# Service Bulletin

Bulletin No.: 21-NA-149

**Subject: Engine Wire Harness Chafing / IPC Gauges Sweep / IPC Warning Message / SES/Check Engine/MIL / No Start / No Crank / Runs Rough / Stalls / Reduced Engine Power / Various DTCs**

**This bulletin replaces PIT5677E, PIT5713A, PIT5751C and PIT5742. Please discard PIT5677E, PIT5713A, PIT5751C and PIT5742.**

5324748

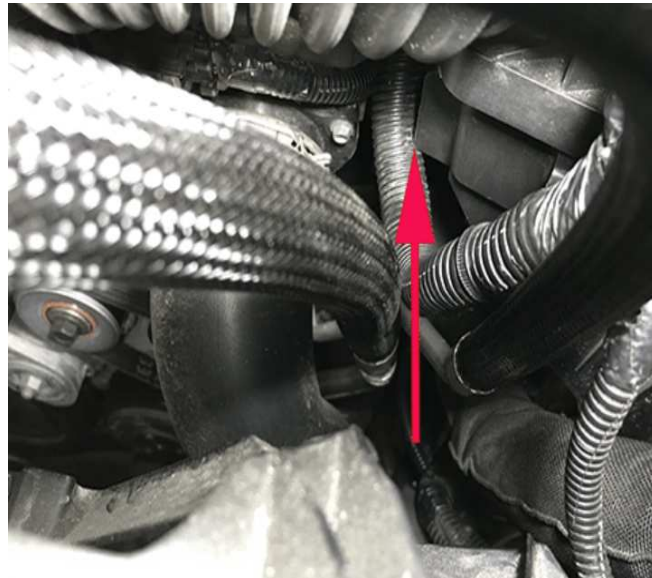
<p><b>Cause 1</b></p>	<p><b>This Cause pertains to vehicles equipped with engine 2.7L, L3B only.</b></p> <p>These concerns may be caused by engine harness contact with under hood components.</p> <p><b>Caution:</b> This Document Only Applies To VINs NOT Covered by Customer Satisfaction Program N192219370 Please Verify In VIS Before Proceeding</p> <p>Shown below are areas that should be inspected for this concern.</p> <p>Inspect the engine harness as it crosses over top of the Camshaft Carrier Cover. Harness damage can occur at any point across the Camshaft Carrier Cover. Typical inspection locations shown below.</p>  <p style="text-align: right;">5394681</p> <p>Example of engine wiring harness damage at Camshaft Carrier Cover shown below.</p>

Inspect the engine harness at the Lower Air Cleaner Housing as shown below.

5324752

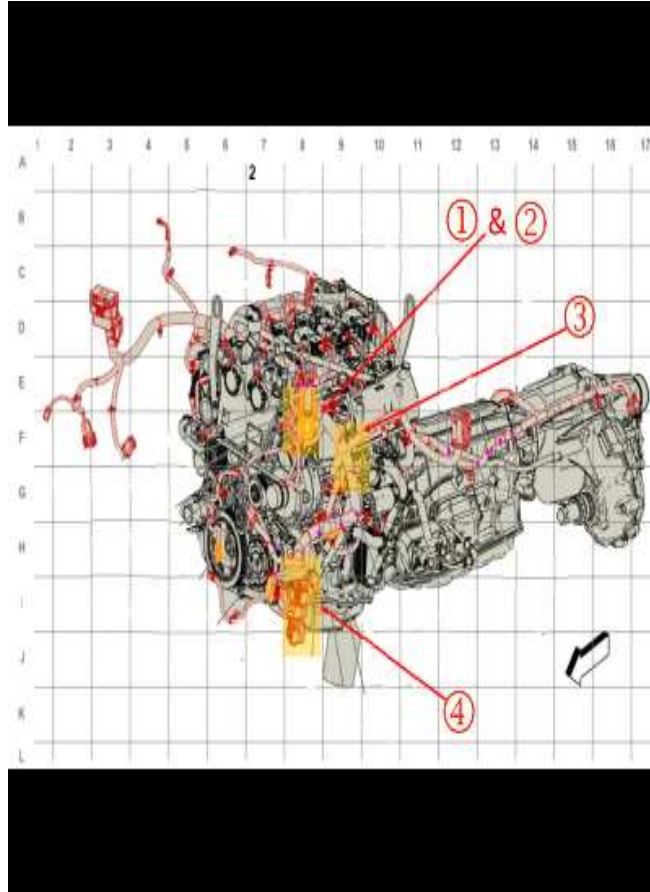
Example of engine harness damage, Lower Air Cleaner Housing removed shown below. Inspect the engine harness at the Generator Bracket and Left Front Coil Spring stud as shown below.

**Note:** Under normal driving conditions, the engine will rock back and forth in its mounts.

This may result in harness contact with this bracket that may not be present during engine off inspections.

Careful visual inspections are necessary to isolate areas of contact.

It may be necessary to disconnect several engine harness connections to reposition the harness for inspections.

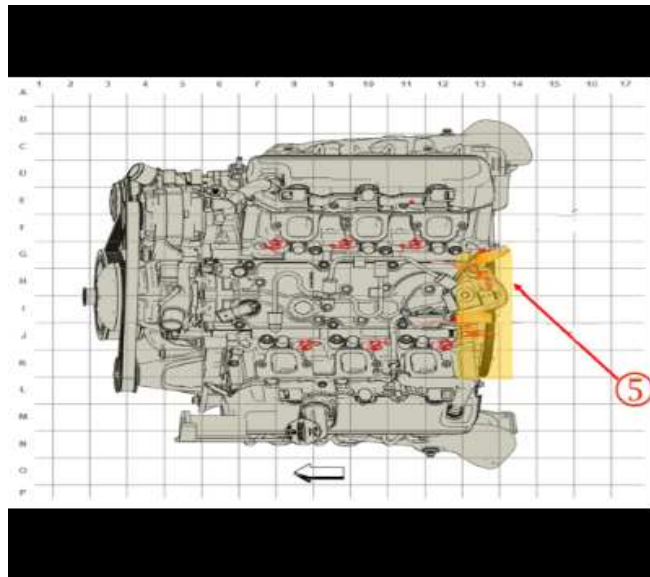
These concerns could be caused by engine wiring harness chafe on underhood components at various locations:

- Front corner of the left hand cylinder head (1)
- Drive belt idler pulley bracket (2)
- Oil Dipstick bracket (3)
- ECM/TCM bracket (4)

- Fuel Rail (5)

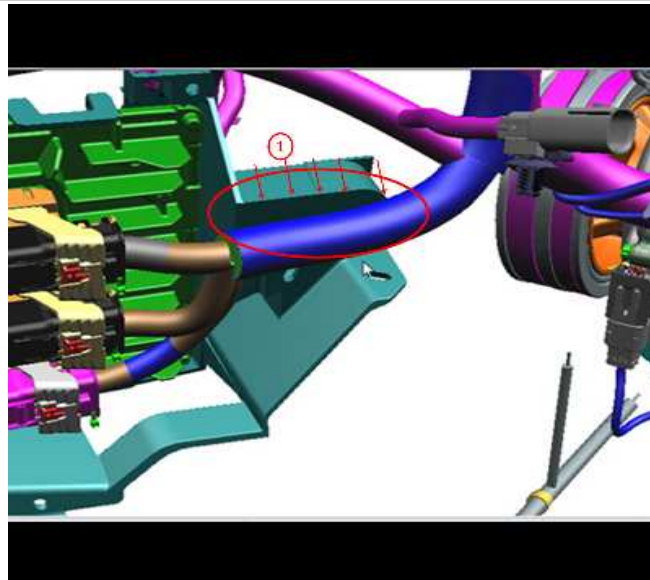
Examples of extreme wire chaffing.

The cause of the condition may be an engine wire harness clip was removed during production due to ergonomic issues (hand clearance and branch stiffness). This led to an uncontrolled branch that came into contact with a sharp edge (1) & (2) on the ECM/TCM bracket, driver side upper control arm, and/or shock tower and caused chaffing during engine vibration and roll.

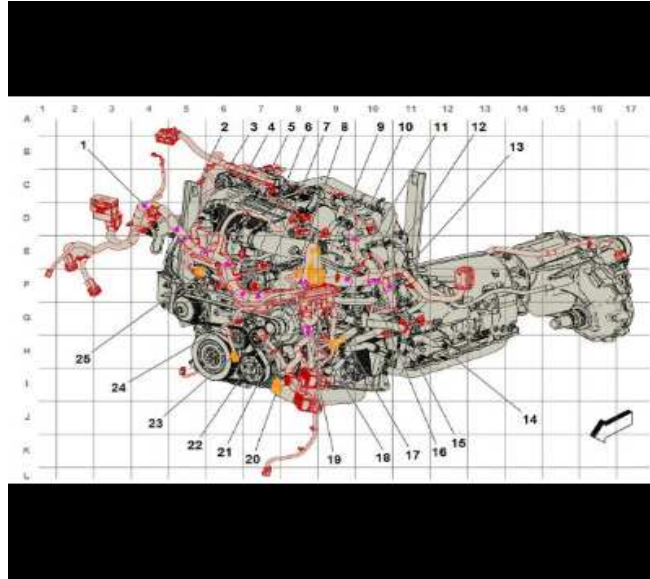
**This Correction pertains to vehicles equipped with engine 4.3L, LV3 only.**  
**Note:** The first graphic below is a before, and after (2), repair example of harness chaffing at the Oil Dipstick bracket.

To correct this concern, repair the damaged wiring following the SI wire-to-wire repair procedures. Once repaired, protect and reposition the engine wiring harness to prevent future harness damage.

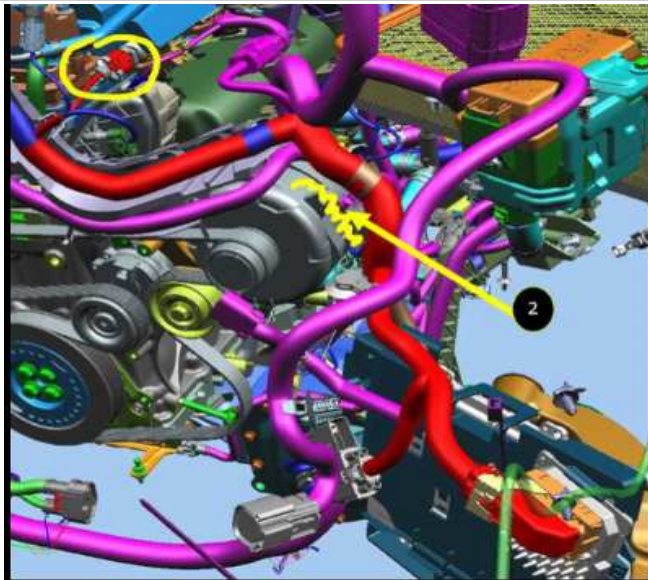
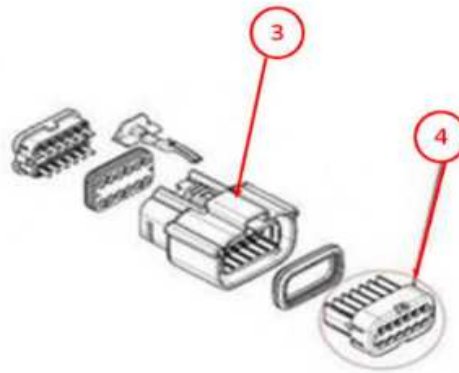
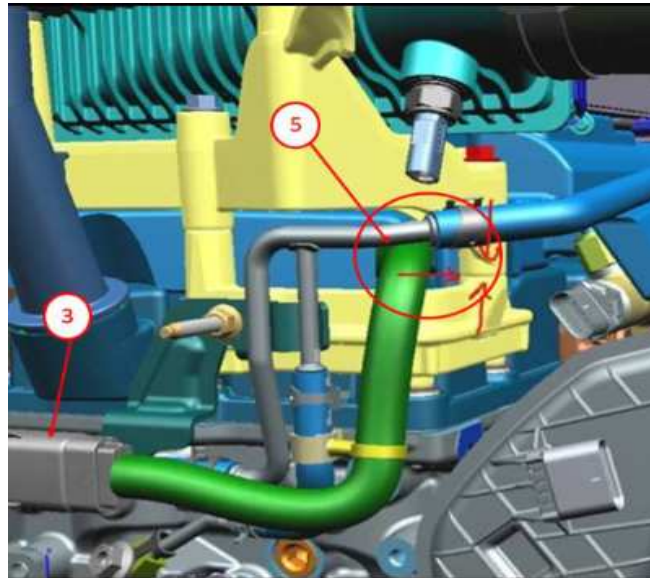
In many cases, the ECM has been unnecessarily replaced for these concerns. Please thoroughly inspect the areas shown above and follow published SI diagnostics before any parts are replaced. If any concerns are found, then follow SI Wiring and Connector repair instructions to correct the concern.

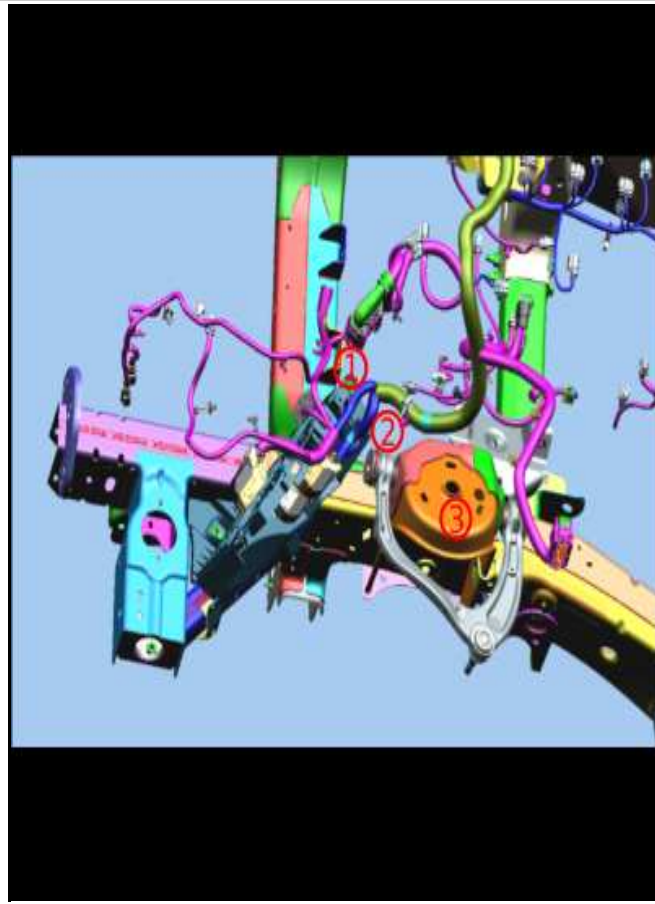
3. Locate the three contact points where the wire harness is chaffing, the ECM/TCM black bracket (1), the upper control arm (2), and the shock tower bolt (3).

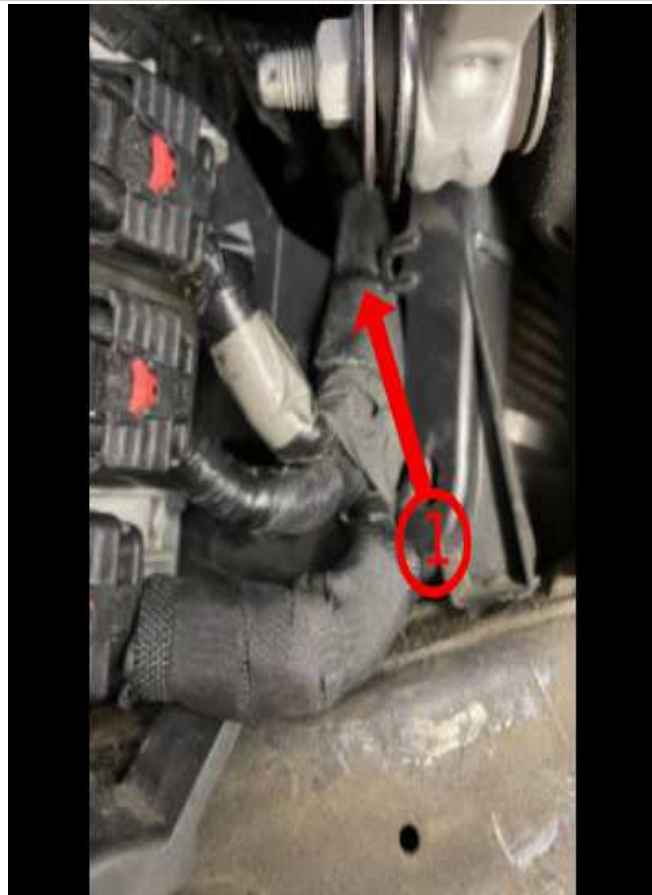
4. At the ECM/TCM bracket, locate the wire harness laying against the ledge (1).

5. Wrap the wire harness with the shorter Engine Harness Sleeve then utilizing zip ties and two small holes in the bracket (1).

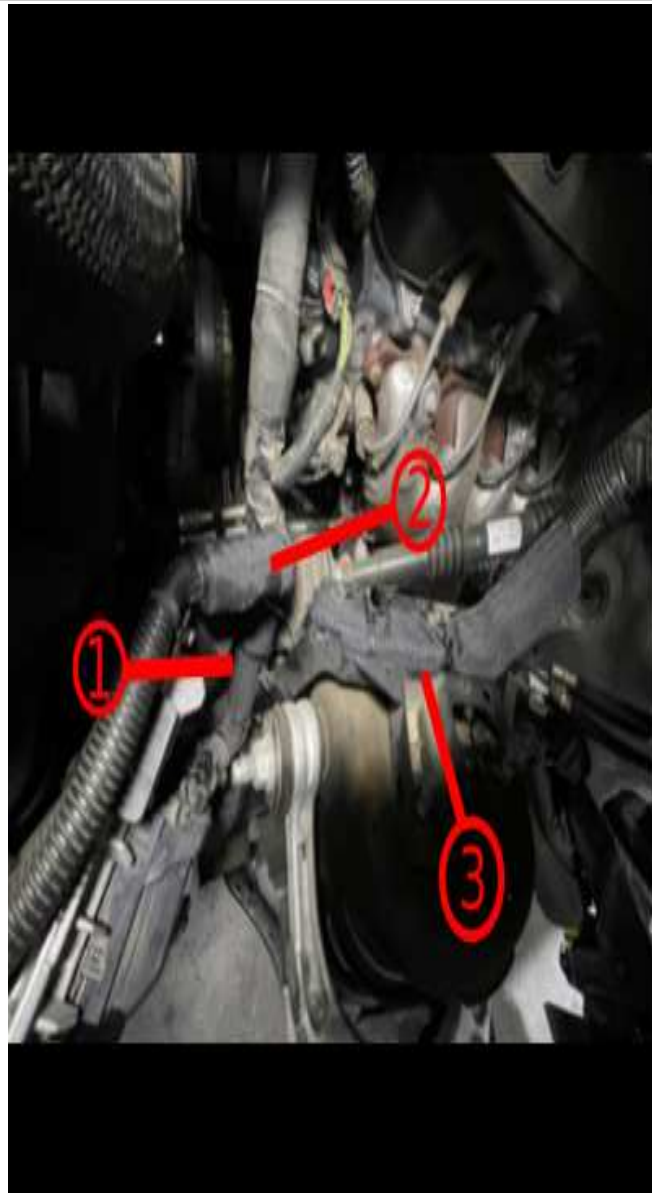
9. At the shock tower point there is a wire harness canal (1).

10. Using the long Engine Harness Sleeve, wrap the harness and secure it snug to the canal using zip-ties.

11. Verify the wire harness is wrapped and secured at all three points, the ECM/TCM Bracket (1), Upper Control Arm (2), and the Shock Tower (3). Then reassemble the vehicle.
12. Reinstall the front wheelhouse liner and tire and wheel. Refer to *Front Wheelhouse Liner Replacement* and *Tire and Wheel Removal and Installation* in SI.
13. Remove the support and lower the vehicle.
